# Iowa Department of Transportation

## MINUTES OF IOWA DOT SPECIFICATION COMMITTEE MEETING

April 13, 2006

ENGLISH

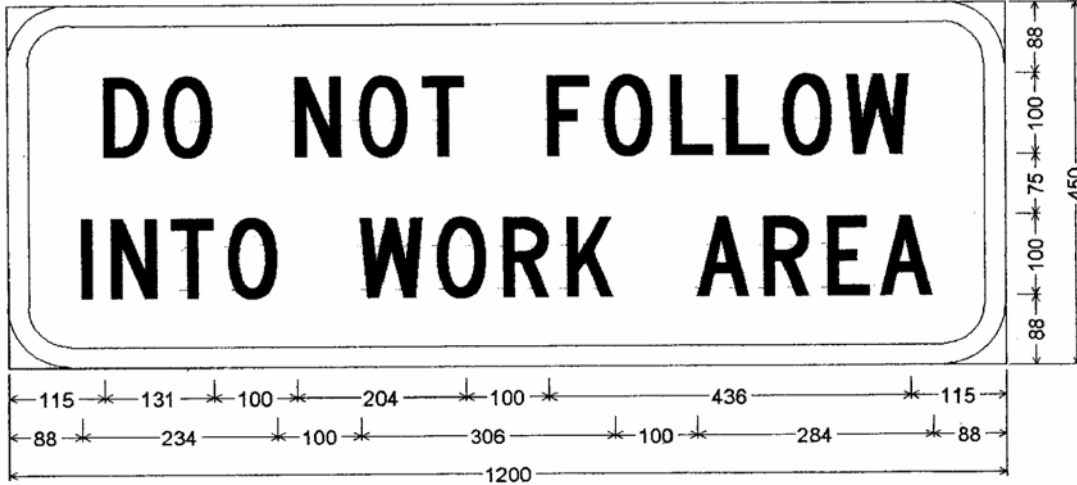
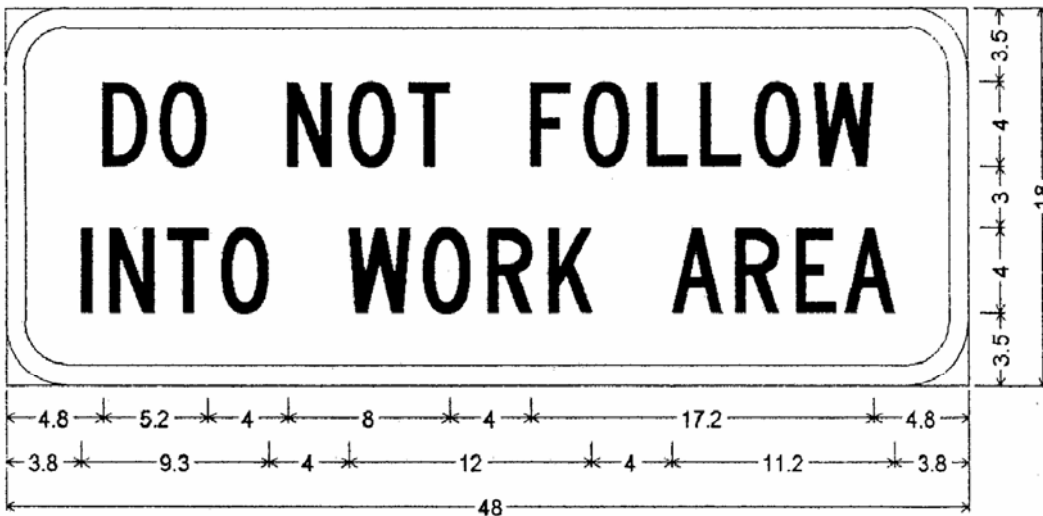
The Specifications Engineer requested a discussion of the proposed changes to DS-01075 that will decrease the size of the required signs, change to the MOM/BOP, and which vehicles are required to carry the signs.

<b>Specification Section Recommended Text:</b> See Developmental Specification					
<b>Comments:</b> Requested by Work Zone Safety Committee.					
<b>Member's Requested Change (Redline/Strikeout):</b>					
<b>Reason for Revision:</b> Modify sign size to allow smaller, yet readable sign and modify the MOM and BOP to make Night Work Lighting a separate bid item, not incidental to traffic control.					
<b>County or City Input Needed (X one)</b>			<b>Yes</b>	<b>No</b>	
<b>Comments:</b>					
<b>Industry Input Needed (X one)</b>			<u><b>Yes</b></u>	<u><b>No</b></u>	
<b>Industry Notified:</b>	<b>Yes</b>	<b>No</b>	<b>Industry Concurrence:</b>	<b>Yes</b>	<b>No</b>
<b>Comments:</b>

75mm Radius, 25mm Border, Black on Orange;  
 "DO NOT FOLLOW" C; "INTO WORK AREA" C;  
 Table of widths and spaces.

3.0" Radius, 1.0" Border, Black on Orange;  
 "DO NOT FOLLOW" C; "INTO WORK AREA" C;  
 Table of widths and spaces.
